Case #: PB 2014-23

Date: October 9, 2014

PLANNING STAFF REPORT

Site: 434 McGrath Hwy

434 McGrath Hwy aerial photo

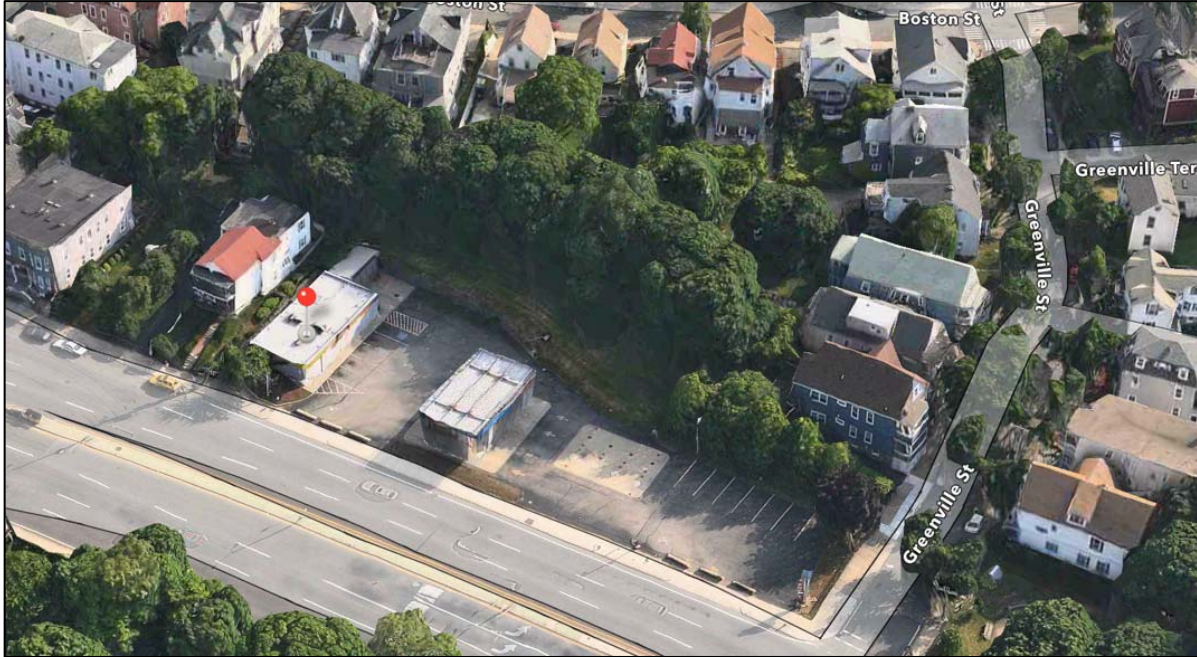
1. Subject Property: The subject parcel is 36,569 square feet and located at the bend in McGrath Highway, and the corner of Greenville Street. The most recent use was as an auto-service and station with a 1,300 square foot service garage. This parcel was rezoned in 2013 from Business B to CCD-45 to further SomerVision, as the Future Land Context Map calls for this site to be Urban residential. The surrounding land uses are primarily residential. While single, two- and three-family dwellings are located in the residential district uphill of this project and in the Business district located along Chester Avenue, there are large-scale apartment buildings located north of the project site.
